**Halton District School Board**

**Addendum No. 3**

**RFT 23-007 Oakville # 3 Elementary School and Child Care Facility**

**ADDENDUM NO. 3** (HAA Addendum #1)

**SMOKE BAFFLES AND DRAFT STOPS FOR STAIR A (typical for Ground and Second Floor u/s Landings)**

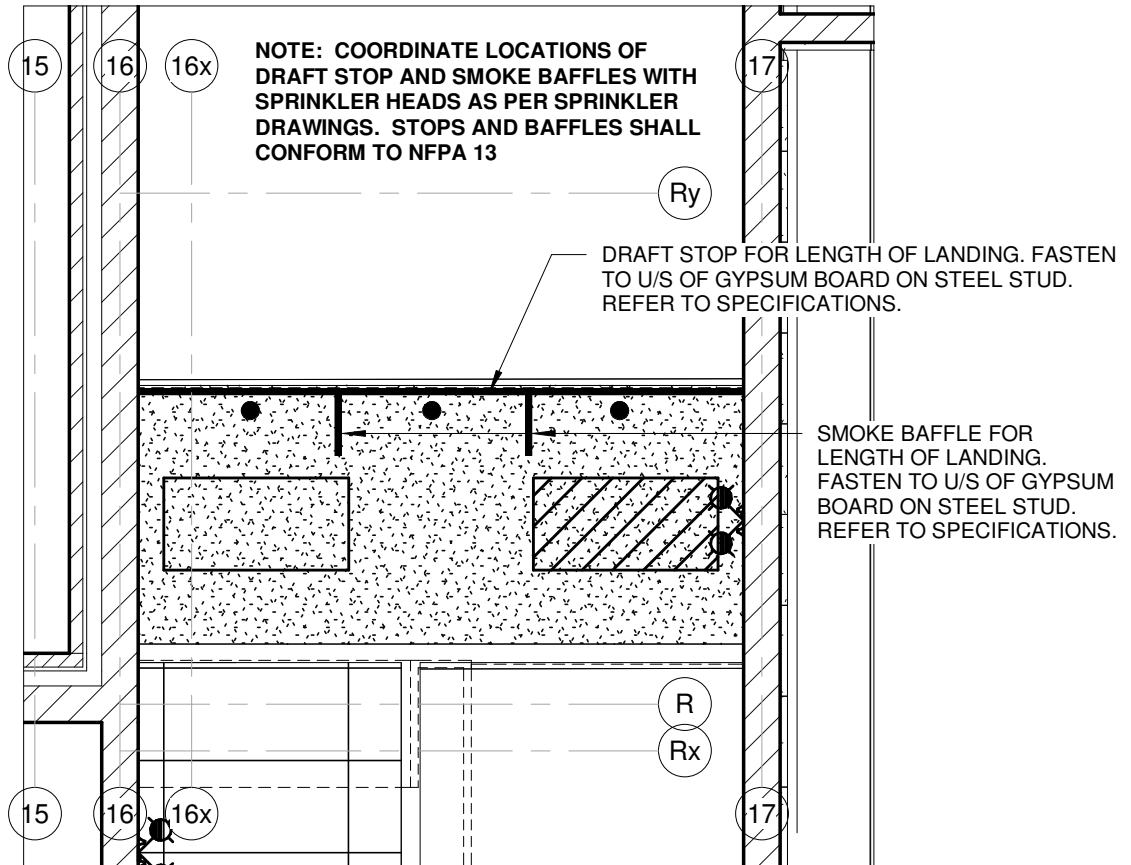
- .1 ADD to Stair A Landing: Smoke baffles and draft stops as per letter size drawing SKA-1, attached herein. Location of smoke baffles and draft stops to be coordinated with sprinkler head locations and lighting shown on electrical drawings. Construction of smoke baffles and draft stops must conform to NFPA 13.

- .1 ADD to Stair A Landing: Smoke baffles and draft stops as per letter size drawing SKA-1, attached herein. Location of smoke baffles and draft stops to be coordinated with sprinkler head locations and lighting shown on electrical drawings. Construction of smoke baffles and draft stops must conform to NFPA 13.

“.22 Smoke baffles and Draft Stops:

- .1 Smoke Baffle / Draft stop shoe by CR Laurence:
  - .1 Catalog Number: B5B10
  - .2 Finish: Mill Aluminium
  - .3 Refer to Glazing Section for glass required.
  - .4 Custom Length to suit locations required c/w end caps.

- .5 Include all accessories required to fasten to gypsum board on steel stud bulkhead.
- .2 Locations: Stair A at u/s of landing at ground and second floors.
- .3 Construction shall conform to NFPA 13.”

Detail 24/A22 SECTION DETAIL @  
EXPOSED STAIR A LANDING (TYP)

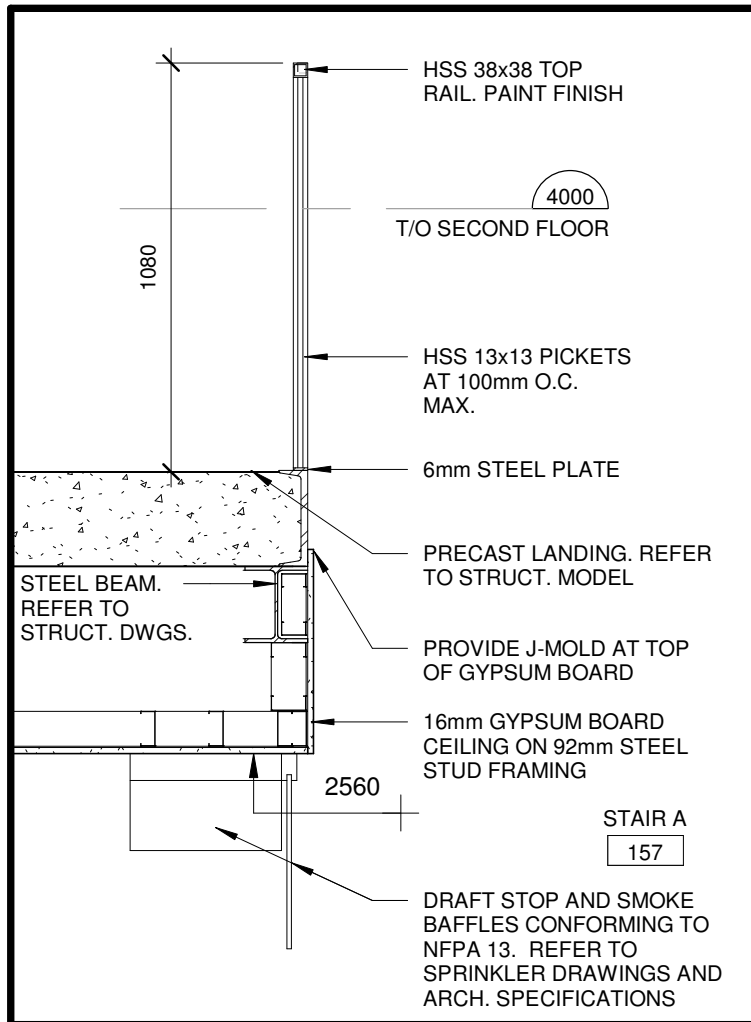
- .1 REPLACE: Detail A24/A22 with A24/A22 as shown on letter size drawing SKA-2, attached herein.

### 1 - DOOR 127B POWER PLAN

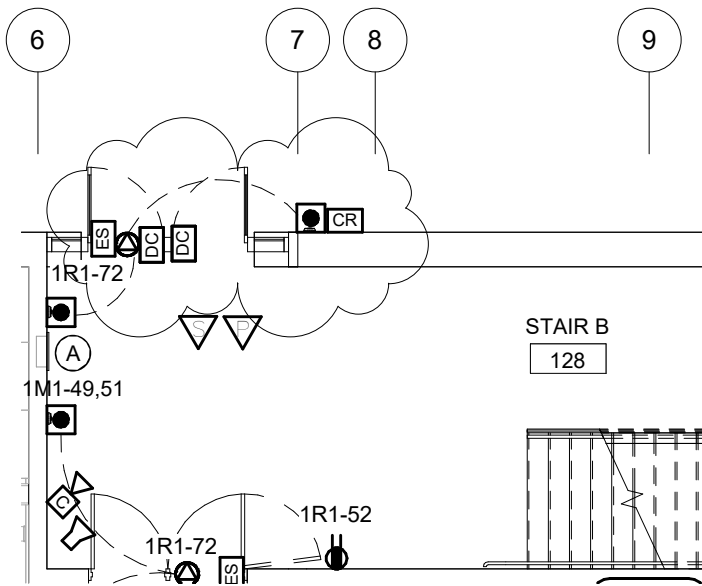
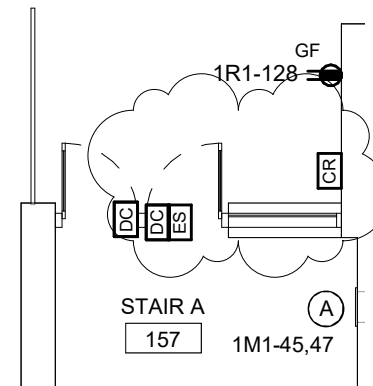
- .1 Electrical contractor to provide card readers for Doors 128B and 157B, at 100mm AFF complete with 13mmC to electric strike in adjacent door frame. Confirm rough-in with door hardware. Refer to attached sketch AD01-E01 and drawing E2.1.
